Report on Indiana Michigan Power Company 2018-19 Integrated Resource Plan

Submitted to the IURC on December 2, 2019

**On behalf of CAC, Carmel Green Initiative, Earthjustice,
IndianaDG, Sierra Club, and Valley Watch**

Figure 1. Bids Received in Response to NIPSCO’s 2018 All-Source RFP⁹

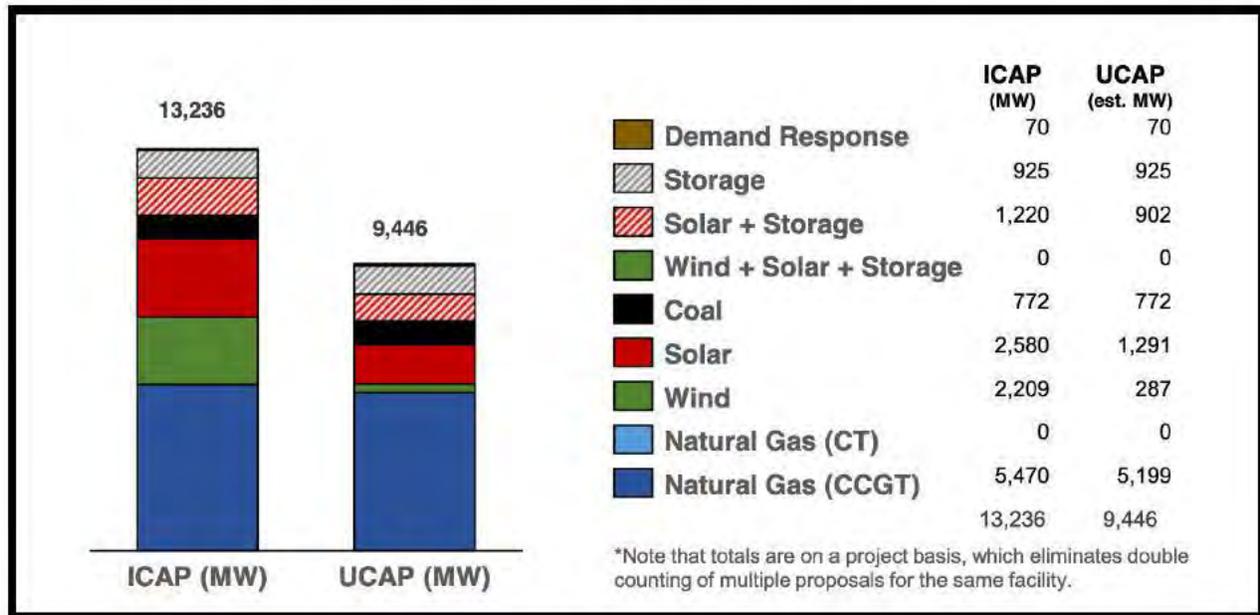
solar + storage hybrid projects (Figure 1) in its 2018 IRP—far more than I&M is even allowing Plexos to select over the entirety of the planning period.

Indeed, in addition to the cumulative limit of 1,700 MW of solar, I&M placed an annual limit on solar so that Plexos could not even select a full 300 MW of solar in each year of the planning period. Solar is first available in Plexos in 2022 and the last year of I&M’s planning period in 2049, that is a 29-year period over which only 1,700 MW¹⁰ of solar can be picked, i.e., an average of 59 MW per year. The limits are arbitrary and not reasonably supported by I&M.

Similarly, I&M’s wind limits are unsubstantiated. The annual limit of 300 MW is well below what can be implemented without constraining ownership to I&M. For example, just one of NIPSCO’s wind farms is 400 MW alone. And I&M’s 2,100 MW¹¹ limit over the planning period is less than the 2,209 MW of wind NIPSCO received in response to its 2018 all-source RFP. Given the 29-year planning period, the 2,100 MW planning period limit amounts to an average of only 74 MW of wind per year. Nor is I&M’s reliance on Department of Energy’s Wind Vision Report appropriate for setting this limit. The intent of the report was to explore a scenario of 10% wind energy throughout the entire nation in 2020, 20% in 2030, and 35% in 2050. It is not a cap on the amount of wind nor would it be reasonable to think that the level of

Figure 2. Incremental Annual Cumulative Net Present Value Revenue Requirement to Base Optimization²⁸

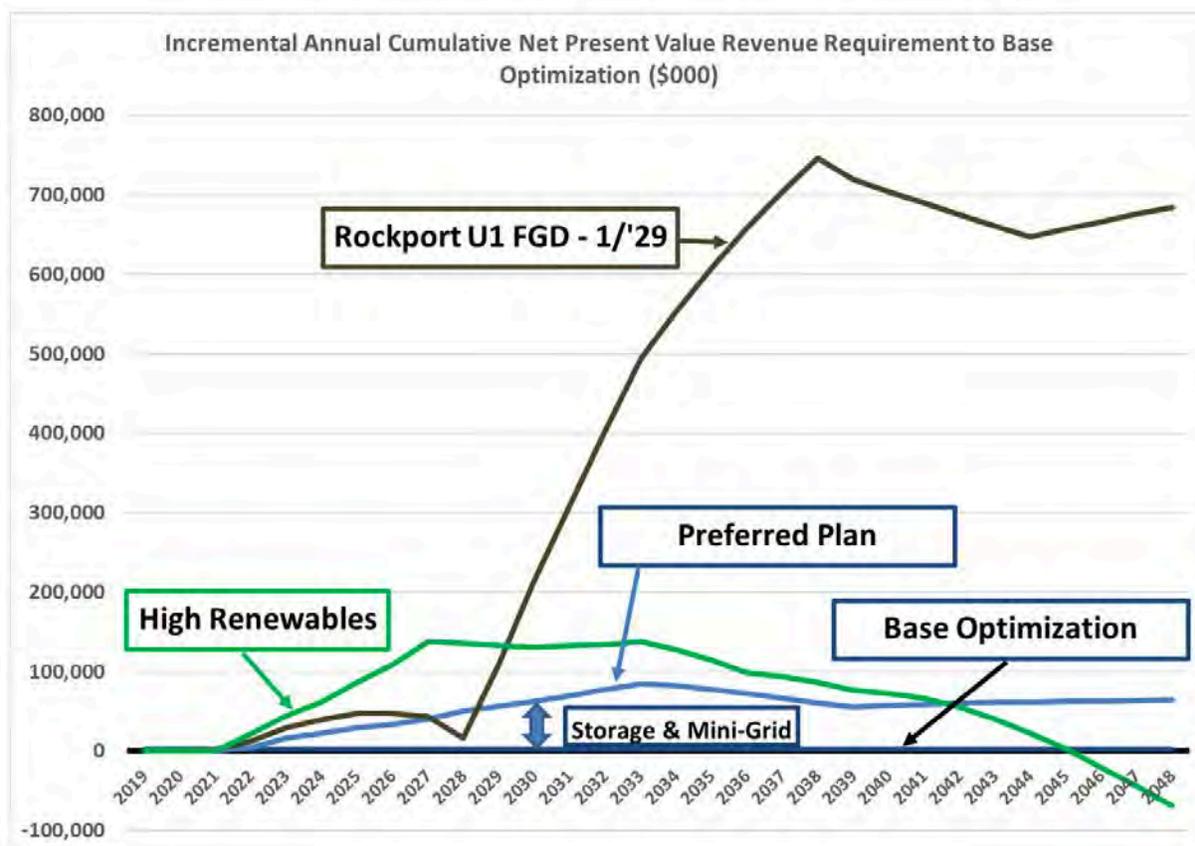
I&M argues that the so called High Renewables plan would have a larger rate impact in the near term in comparison to the other plans shown in Figure 2.

But this differential in revenue requirements is likely to be distorted by I&M’s incorrect modeling of wind and solar prices and the unreasonably low cost it assumed for gas combined cycle units (“CCs”) as discussed in Section 3.2, below.

Figure 4. I&M Historical and Forecasted Sales by Customer Class⁴⁰

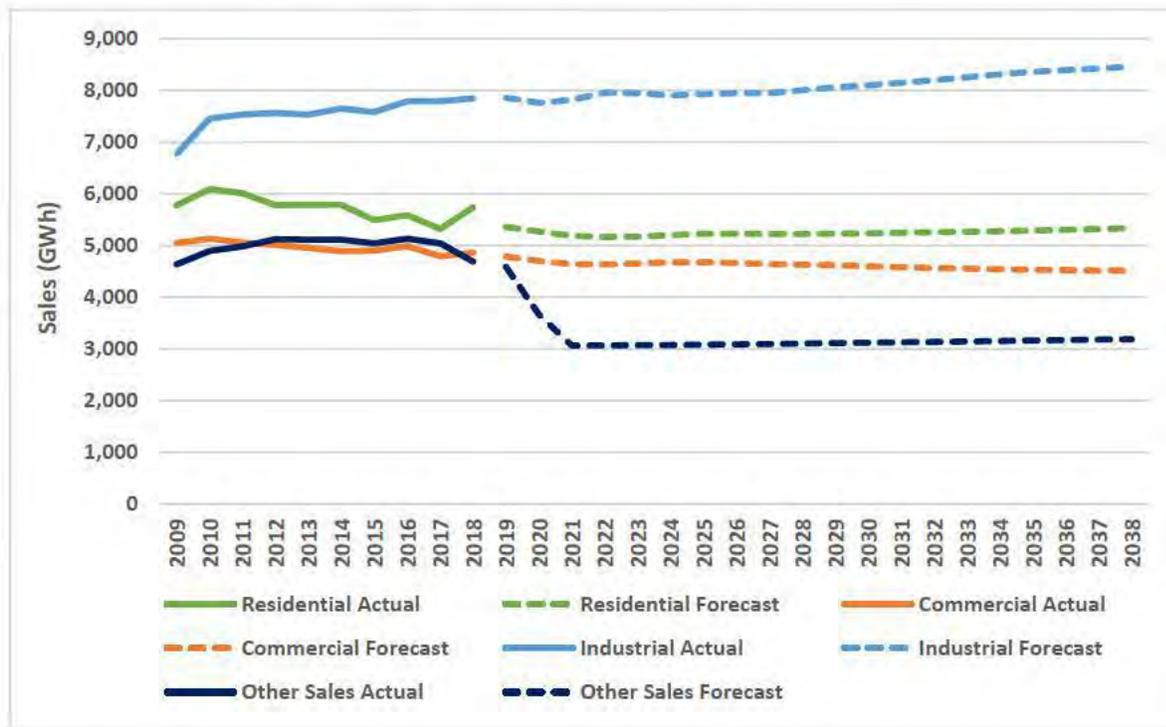
Due to slower growth of sales in some of the customer classes and the loss of certain wholesale customers, I&M’s forecasted sales have a lower average growth rate than the historical. Figure 4 shows the comparison between historical and forecasted sales across each of I&M’s customer classes. I&M is forecasting a drop in wholesale customers which results in a large dip in sales.

I&M also projects that Company wholesale customer sales will decrease from 4,509 GWh in 2019 to 3,586 GWh in 2020 and then 2,988 GWh in 2021.³⁹

Figure 7. I&M Residential “Realistic Achievable” Cumulative Savings from AEG MPS (GWh)

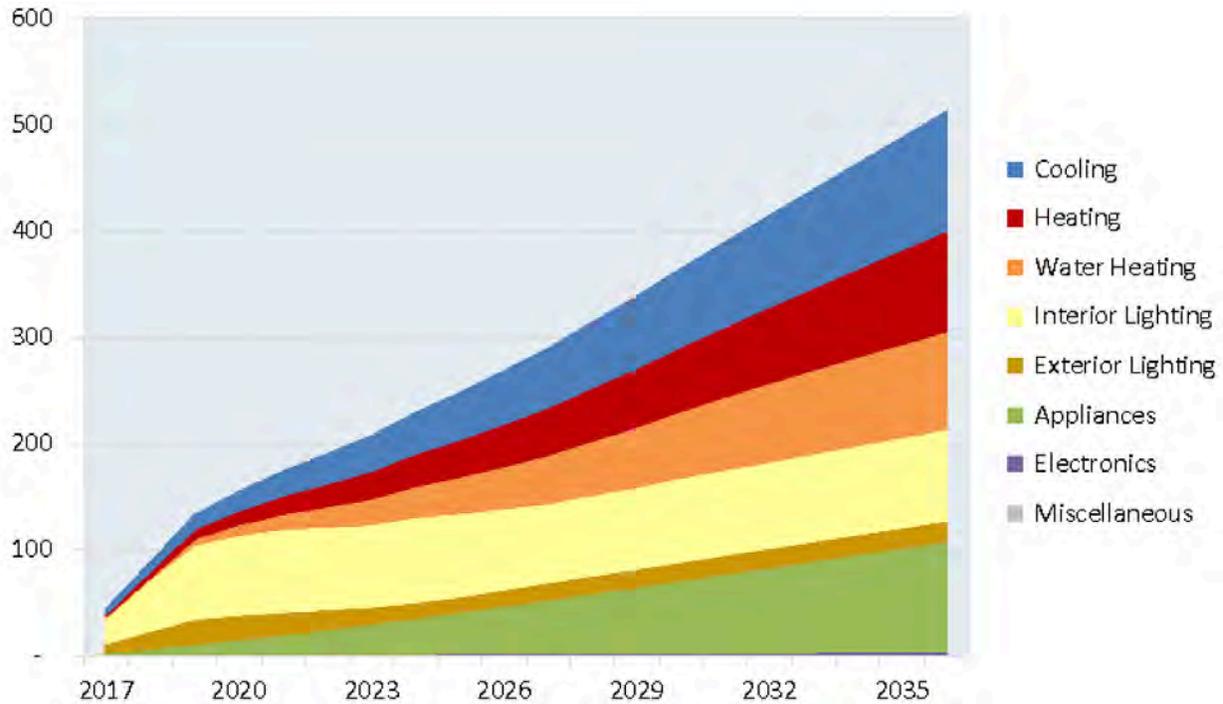
While residential lighting is a measure with significant savings in contemporary MPSs performed on behalf of Vectren⁵⁰ and Indianapolis Power and Light,⁵¹ it was not included as a bundle for potential selection until 2030 in I&M’s modeling. I&M’s MPS does show significant cumulative savings from residential lighting, as shown in Figure 7, below, but the MPS only reports cumulative savings by end-use from 2017 onwards, not incremental savings. So it is impossible to accurately separate the incremental potential for lighting savings from the savings from prior measure installations that may or may not be rolling off.

Nevertheless, this figure from I&M’s AEG MPS certainly does not support an assumption of zero incremental residential lighting savings through 2030. Indeed, I&M does not even believe that is a reasonable assumption in the near term since I&M Witness Jon Walter testified in his direct testimony filed in Cause No. 45285 that I&M’s upcoming three-year DSM plan includes a program with a residential lighting component.⁵²

Figure 8. I&M Historic Savings Goals Are Materially Higher than Net Potential in MPS

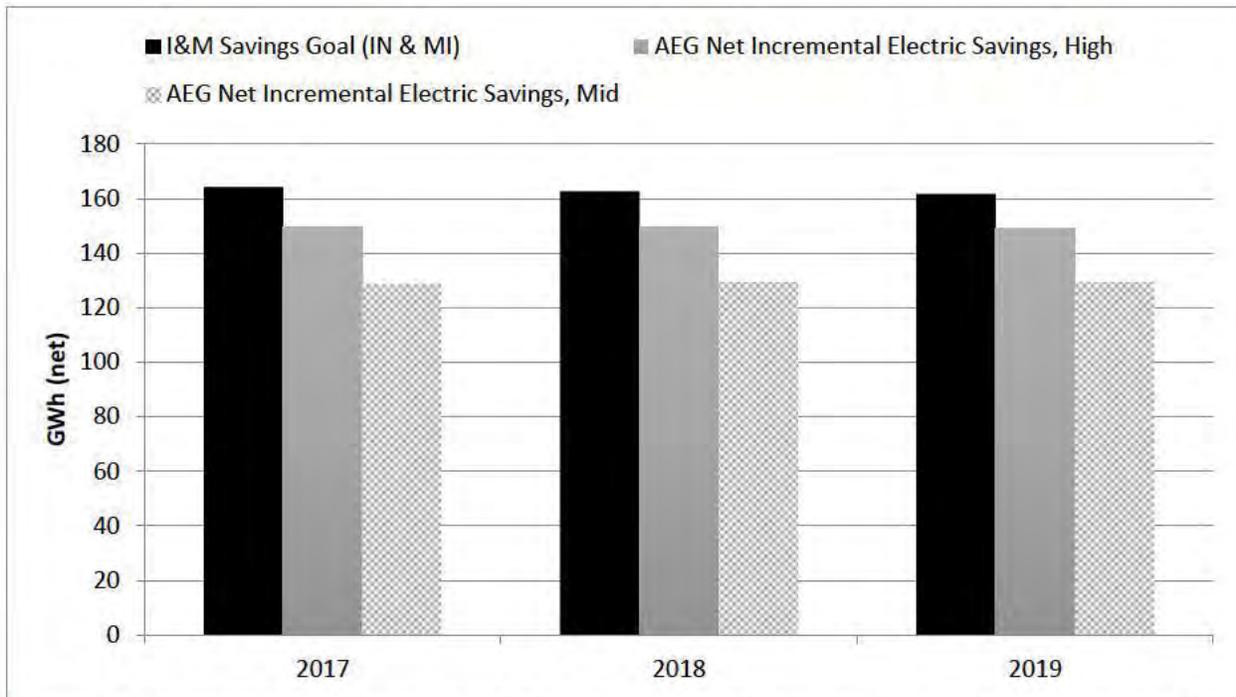
Initially, I&M planned to base its EE bundles only on the Top 20 measures in terms of cumulative annual savings in the MPS. After input from stakeholders, “potential was added from measures outside of the top 20 measures into a ‘miscellaneous’ bundle for each sector.”⁵³ Yet, incremental savings either in the MPS – which are theoretically supposed to be based on maximum achievable cost-effective savings - do not even reach the modest levels in I&M’s historic combined goals across Indiana and Michigan service territories as shown in Figure 8 below.

The black bars show I&M’s combined savings goals across its two-state territory and are significantly higher than I&M’s AEG MPS savings.

Figure 9. IRP Cannot Result in Level of Savings Equal to I&M's Current Goals

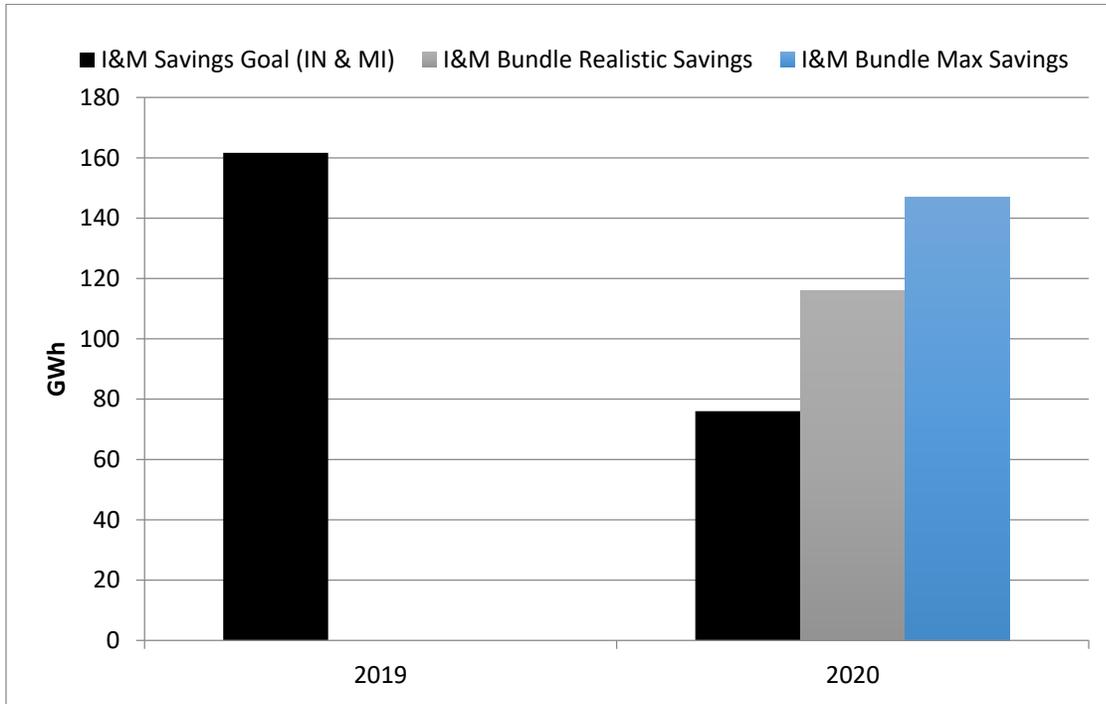
The IRP bundle savings also do not match up with I&M’s most recent goals as show in Figure 9. Note that the 2020 goals are based on this IRP and are a function of the very low potential modeled in I&M’s bundles as well as the elevated cost of those bundles.

Figure 10. 2019 EE Budget Achieved More Savings at Lower Cost than IRP Bundles Would

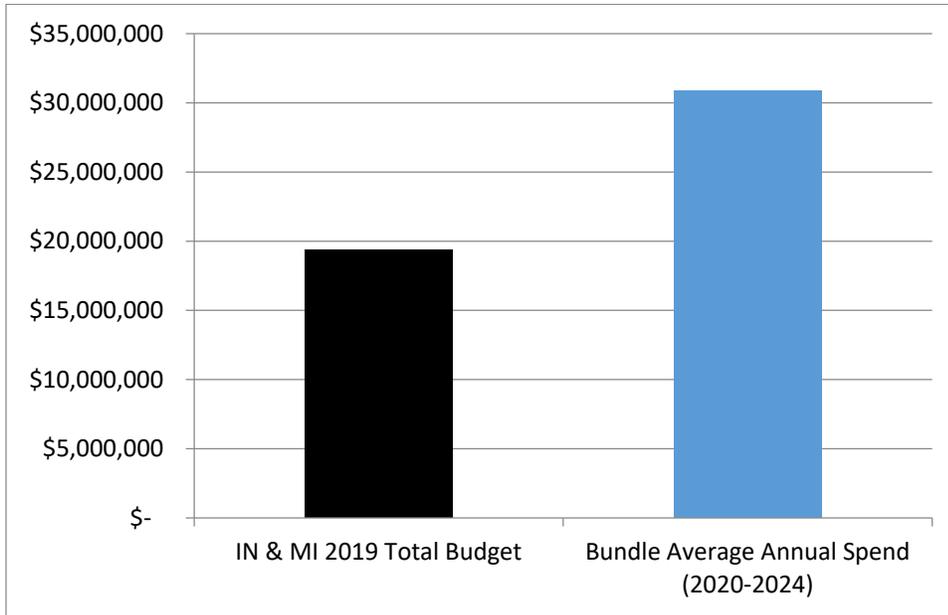
The cost of the IRP bundles may be different than the MPS costs - we are not clear on that point because savings are grouped in the bundles differently than they are in the MPS. But whatever the source of the bundle costs, they are dramatically higher than I&M's two-state EE budget for 2019 (Figure 10 below) which is forecasted to achieve much higher savings as shown in Figure 9 above. In other words, I&M's customers are getting more savings for less money in 2019 than what I&M has modeled for 2020 and beyond.

I&M has utterly failed to model EE savings in any way that represents a) the manner in which those savings are actually achieved, b) a level consistent with its own MPS, or that represents c) the likely maximum achievable level of savings. These errors compounded upon other errors explained above create fatal, irredeemable flaws in I&M's 2018-2019 IRP.

Figure 12. I&M's 2020 Energy Mix

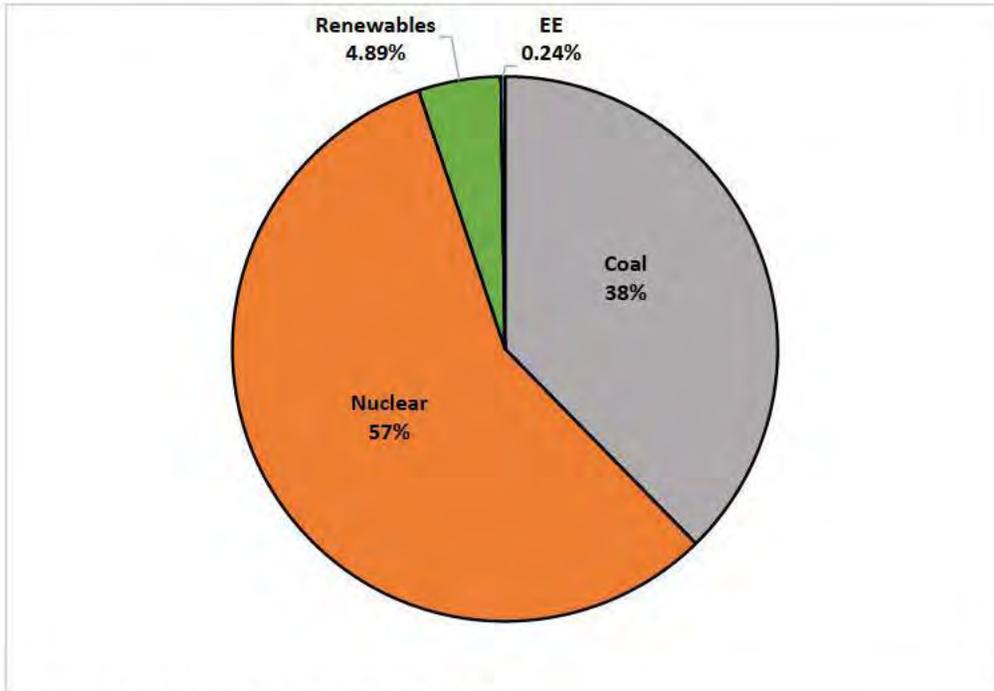
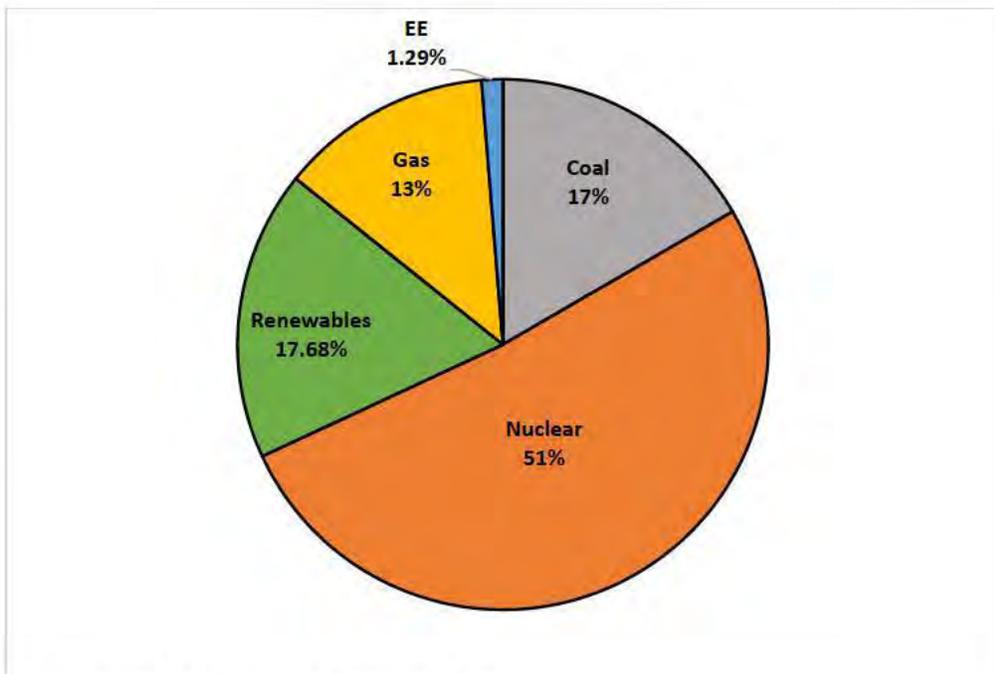
I&M’s short-term action plan is a product of the many flaws contained in its IRP. I&M’s biases against energy efficiency, wind, and solar in favor of thermal resources, result in a plan that underutilizes the first category and over utilizes the second. The result is a plan that goes from being very heavily dependent on thermal resources, specifically coal and nuclear power, to one that is still dominated by thermal resources that now includes gas, as shown in Figure 12 and Figure 13.
